OhioHealth Administrative Offices and North Parking Lot Development

Stormwater Drainage Manual Type 3 Variance Application COMMENTS (dated June 21, 2017)

OhioHealth 100 year floodplain (FEMA FIRM)

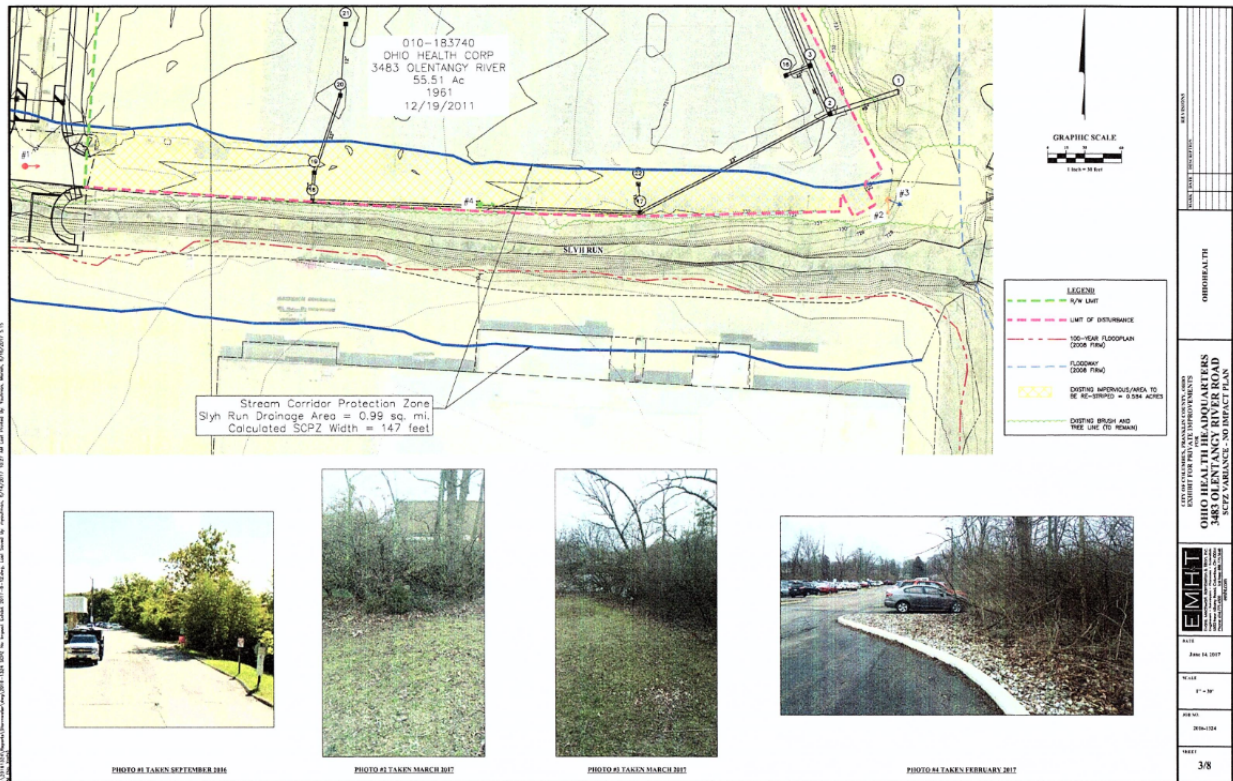
1. The Friends of the Lower Olentangy Watershed (FLOW) have reviewed the request for a variance and find it to be unresponsive to the needs of the Olentangy Watershed. While we are supportive of the compilation of the OhioHealth employees for the efficiency they require, we do not support the impacts to the watershed. Specifically, we are concerned about the filling in the 100 year floodplain (Section 3.0). **We request information on the volume of floodplain fill and where the compensatory volume will be provided before authorization is given for this project. How will this proposed project impact flooding of other local and downstream landowners?**

Turkey Run East of Olentangy River Rd's existing (blue) and proposed (red) Cross Sections

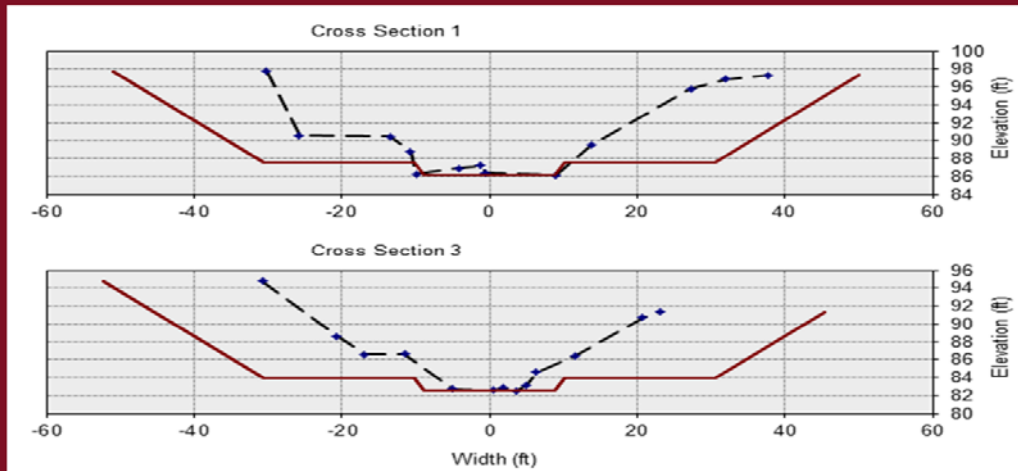
9. If the City decides to approve the SCPZ request, then FLOW requests that mitigation be provided along Turkey Run (and not at Anheuser-Busch Sports Park). We request that the applicant excavate floodplain along Turkey Run to increase the conveyance capacity. Per a study by OSU students (2014), the stream corridor in this area already has the capacity to carry a 50 year storm.

10. FLOW objects to the proposal to conduct mitigation at Anheuser-Busch Sports Park and at the reduced rate of 1:1. Our preference concurs with the SCPZ mitigation strategy to have the mitigation along the same waterways that are impacted. Our first preference is for mitigation on Turkey Run, to increase the in-channel storage capacity via excavation and our 2nd preference is to provide tree canopy to Turkey Run and Slyh Run (after the removal of invasive bush honeysuckle).

Estimated Cost for Mitigation at Turkey Run

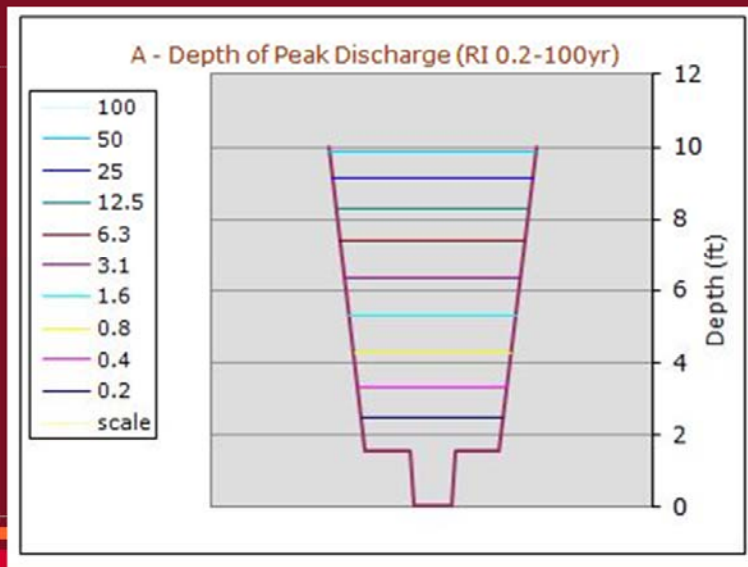
Our Suggestions:

Proceed with constructing a two-stage ditch between Olentangy River Road and OH-315 to connect two quality ecological habitats.

Turkey Run Conveyance Improvements will be effective at conveying the 50 year storm.

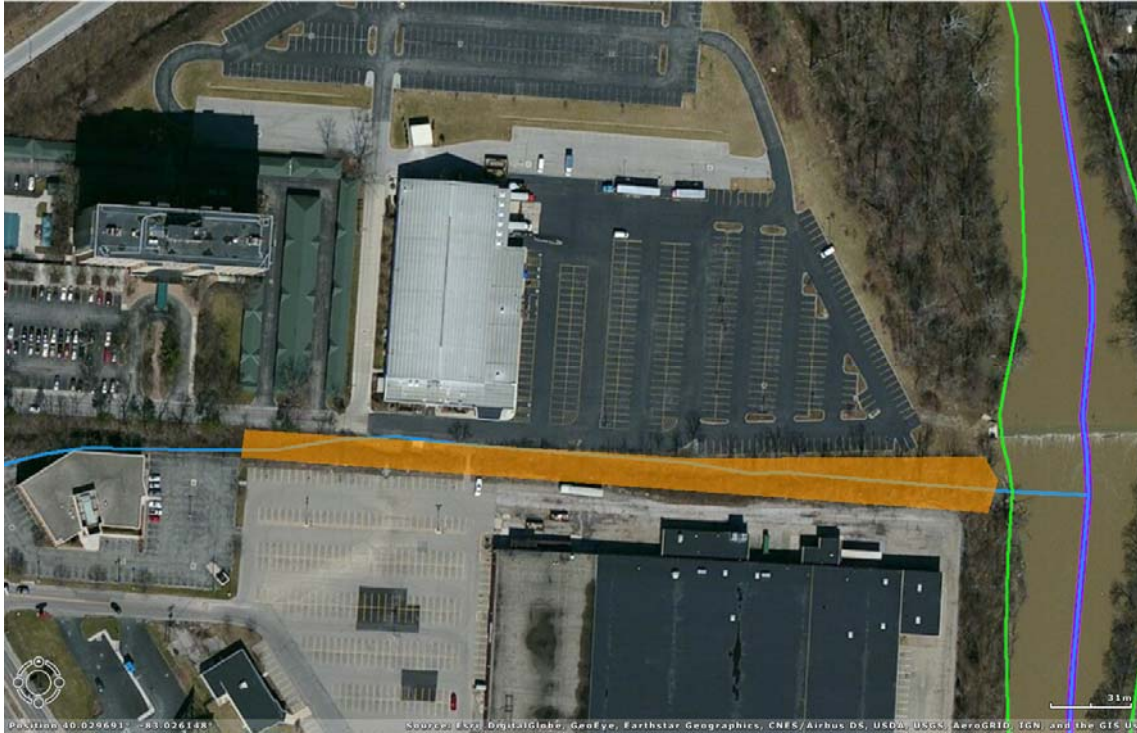
Will it be effective?

Slyh Run- approximate 1 acre Stream Corridor Protection Zone Honeysuckle Removal and Tree Planting area (shown in orange).

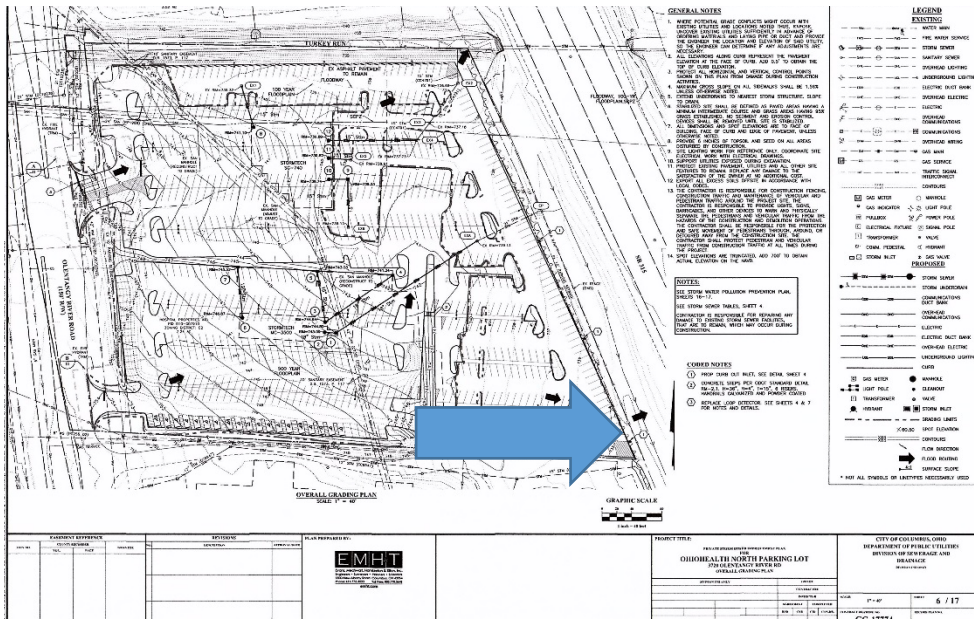
14. Per Sheet 6/17, how will the flood routing for the Turkey Run (North Parking Lot) affect safety on SR 315? Will the flooding result in sheet flow across SR 315 shown by the blue arrow below?
